Purbasha Composite Tex Ltd

Jamirdia (Square Masterbari), Bhaluka, Mymensingh
(24.305554, 90.393209)
21st March 2022

Building Information

Stressed columns in layout

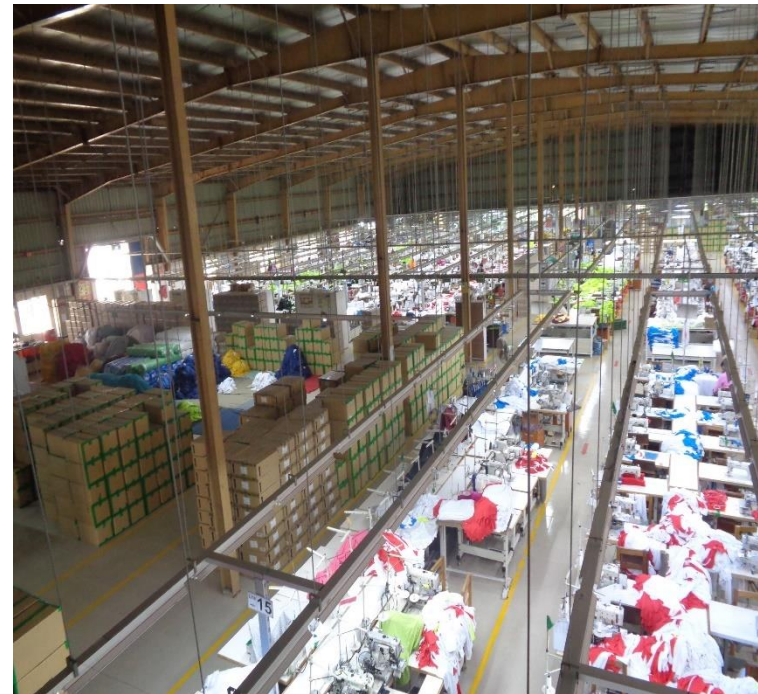
Stress in column exceeds normal design limit

Cursory calculation indicates that stress in column exceeds the normal design limit (yellow marked) due to large tributary area considering the roof live load (1 kPa) and strength of steel 345 MPa from the available MS plate test report. Building engineer is required to review the design, loads and column stresses for the marked columns.

Apparently incomplete lateral stability system

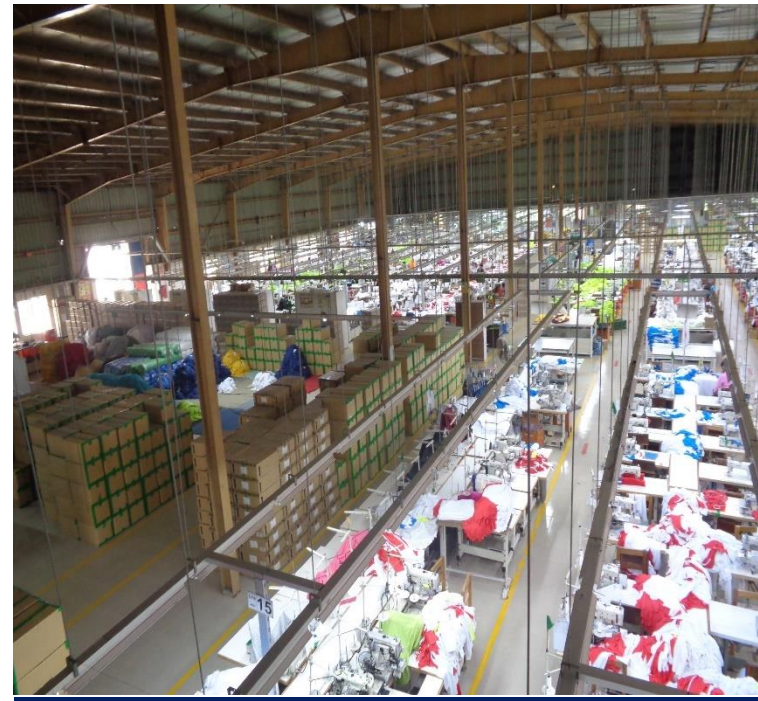
Roof & wall bracing provided

No load transfer media provided

Roof and wall bracing provided at some location, but no-load transfer media provided from frame to frame to transfer the lateral load therefore lateral stability system of the shed is apparently incomplete. Also, the wall bracing seems to be inadequate if considered as both tension-compression Building engineer is required to check the lateral stability of the structure.

Columns appear to be slender

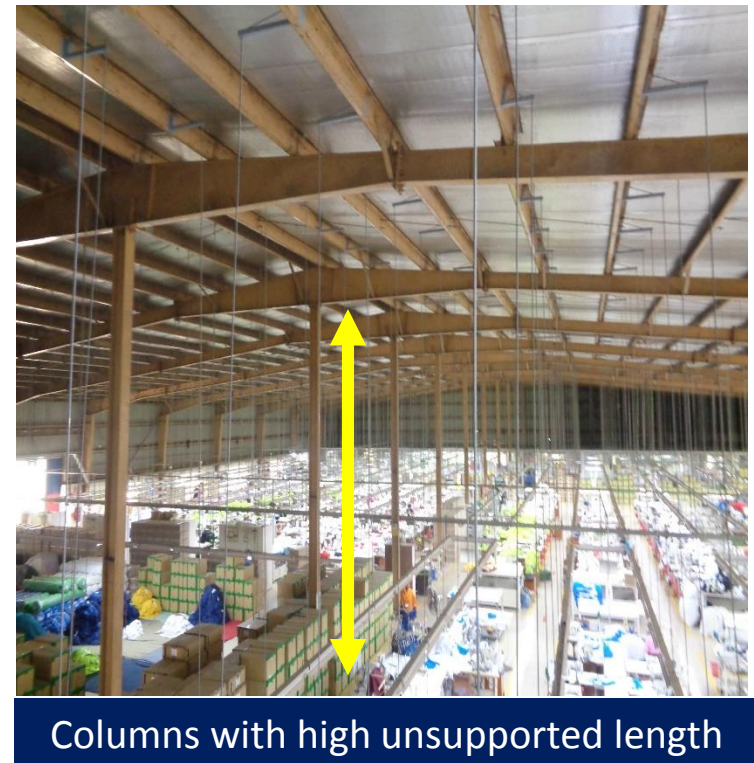
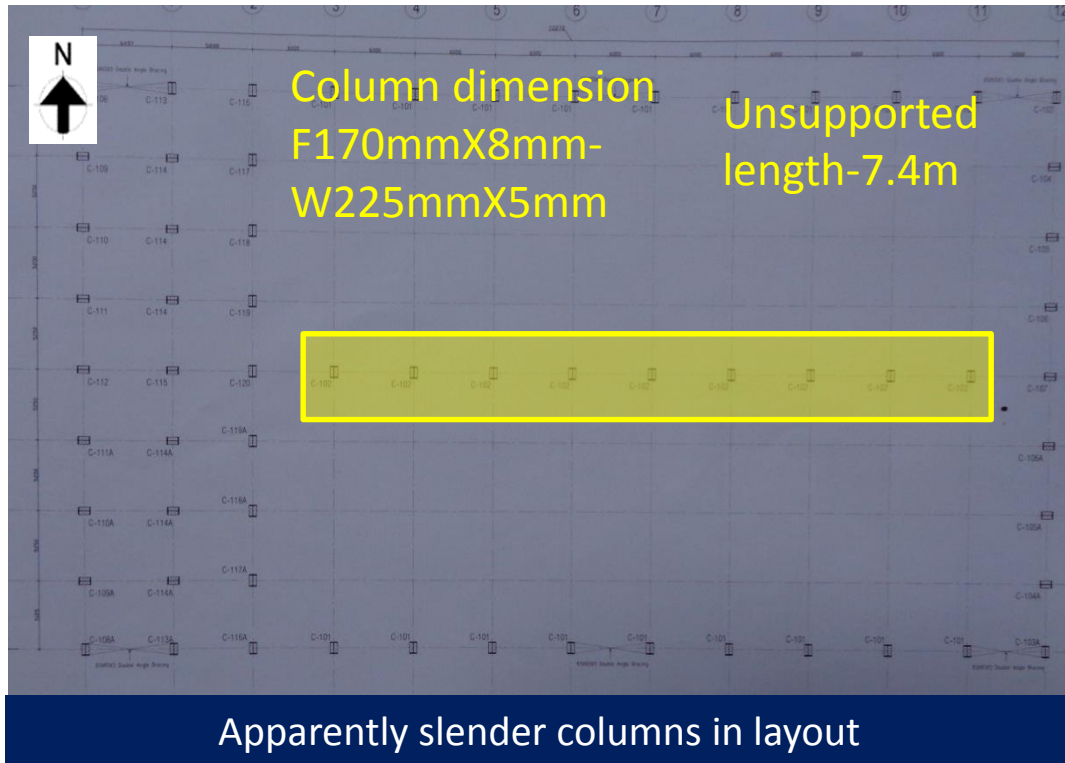
Cursory calculation shows that slenderness in highlighted columns exceeds normal design limit due to long unsupported length. Factory engineer is required to carryout adequacy check of the highlighted column considering slenderness effect.

**Prepared structural analysis report to be updated
and reviewed**

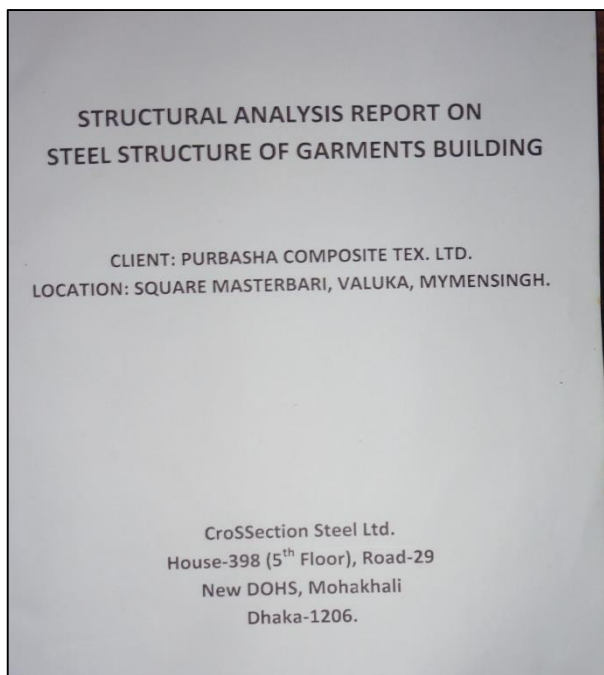
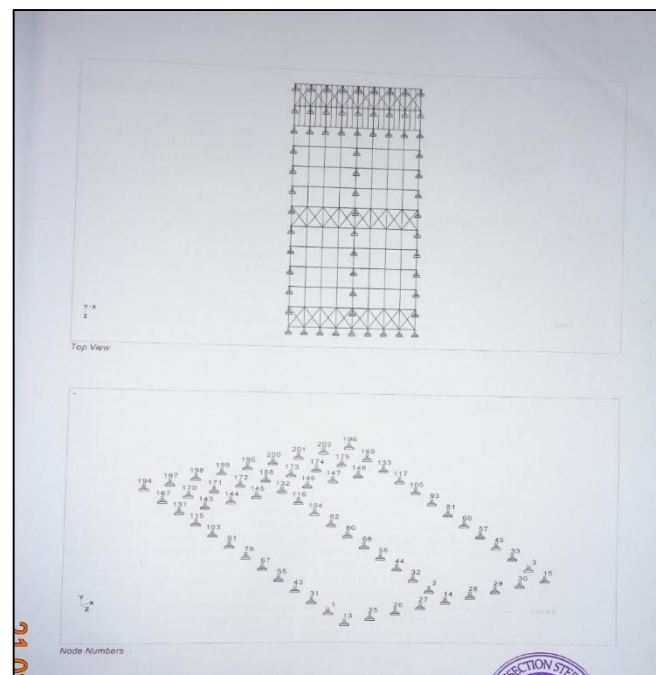
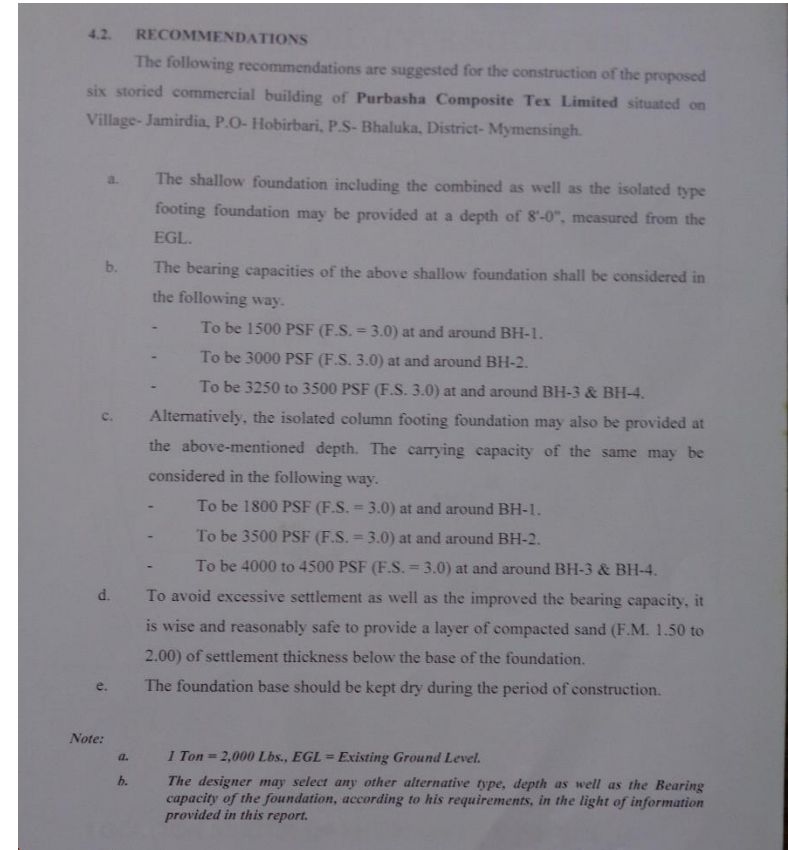
Prepared “Structural Analysis Report”

“Structural Analysis Report” based on FEA model

A “Structural Analysis Report” was available based on software-based analysis for this structure. However, no software model was available to review the analysis report. Also, there is not foundation capacity check is included in this report.

As per BNBC, every building or structure designed shall have its design documents prepared in accordance with the provision of Section 1.9.1. The design document shall include a design report, and a set of structural drawings, which shall be prepared in compliance with section 1.9.1.1 and section 1.9.1.2 as per BNBC. Building engineer is required to produce a full set of analysis report as per section 1.9.1 including adequacy check of all type steel members, pedestal column, Grade beam & foundation and submit along with the software model for further review.

Prepared load plan to be revised

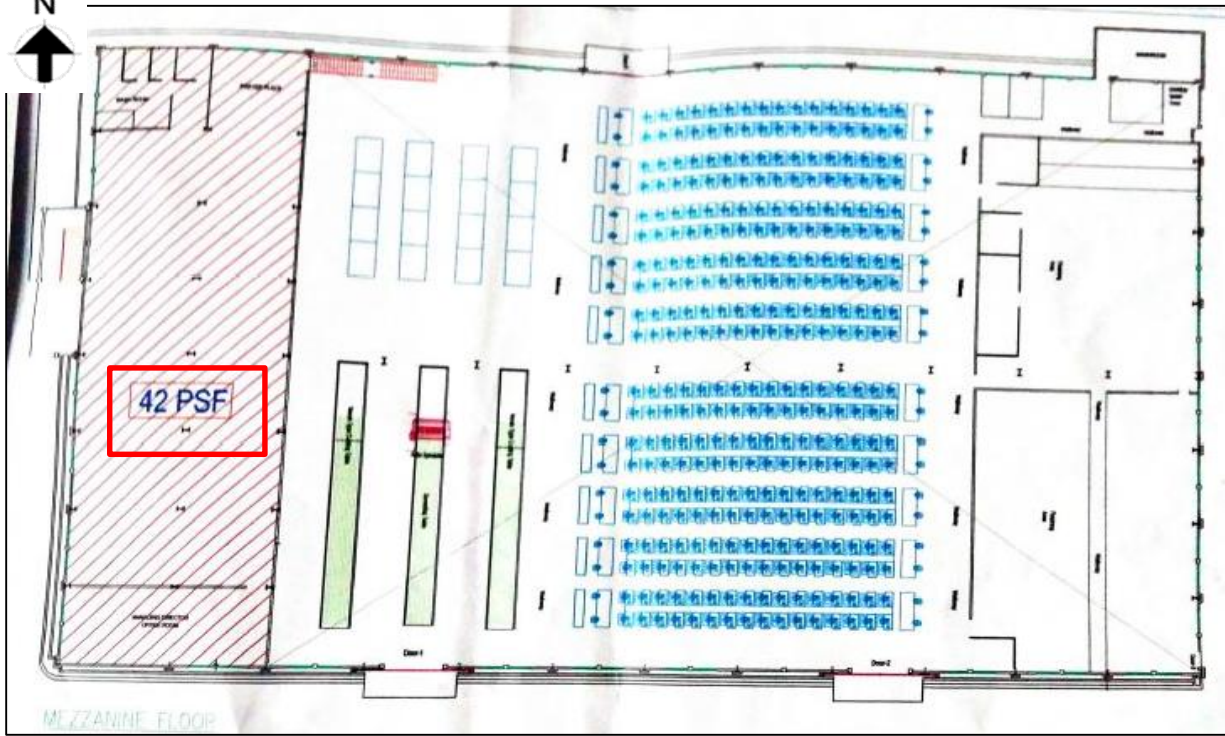
Live load plan-Mezzanine floor -2 kPa

Live load on Mezzanine floor is considered as 2 kPa in prepared load plan. As per BNBC- Part 6, live load for light storage and prayer areas is required to be considered minimum 6 kPa and 3 kPa respectively. However, the building engineer is required to revise the load plan as per BNBC requirement and check the design accordingly.

Absence of design documents and as-built drawing

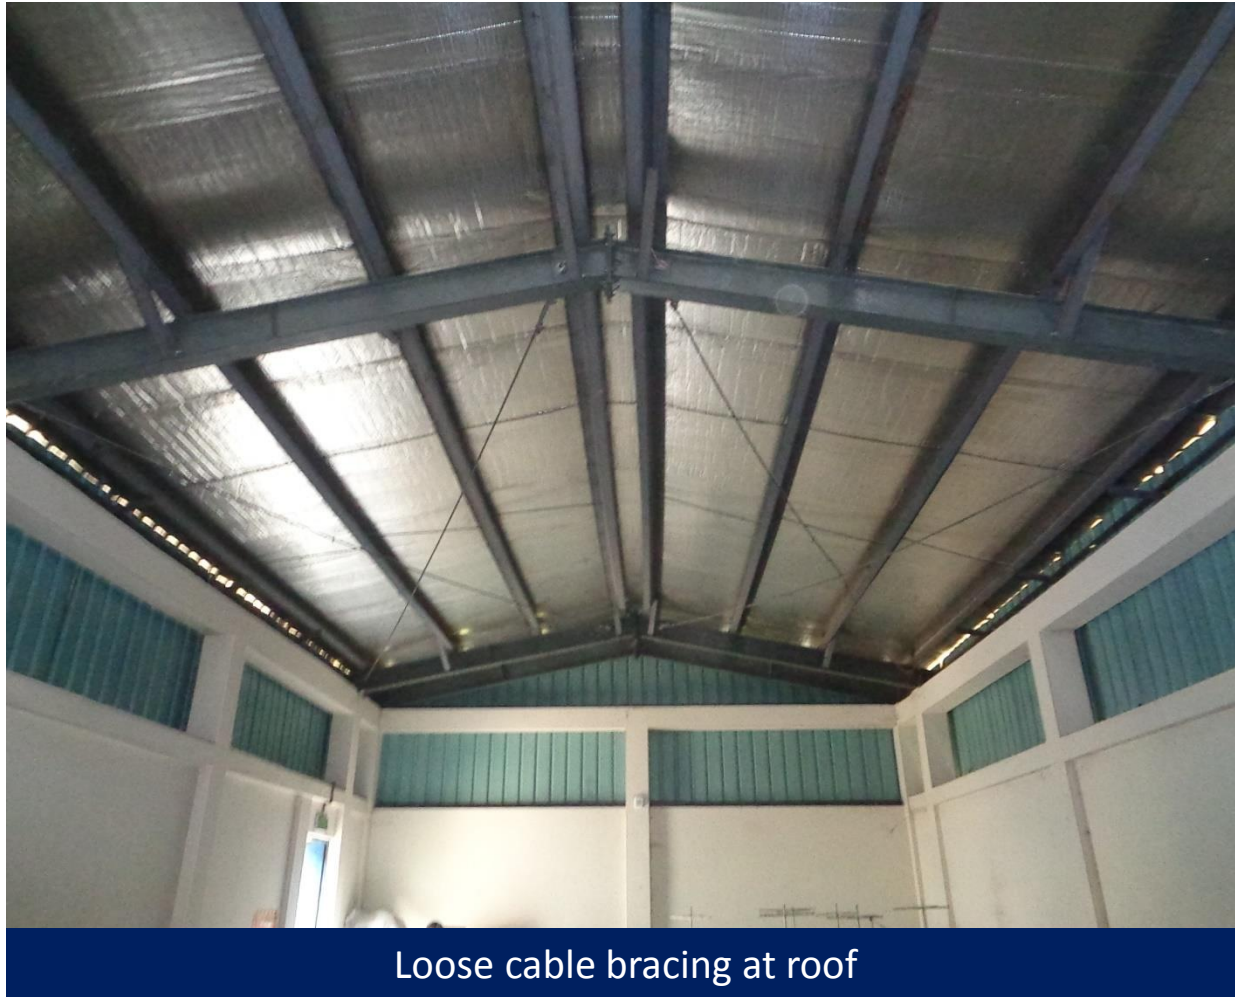
As per BNBC, every building or structure designed shall have its design documents prepared in accordance with the provision of Section 1.9.1. The design document shall include a design report, and a set of structural drawings, which shall be prepared in compliance with section 1.9.1.1 and section 1.9.1.2 as per BNBC. At the time of inspection, no as-built drawing or design report was available which are required to be prepared in compliance with section 1.9.1.1 and section 1.9.1.2 (part-6, BNBC).
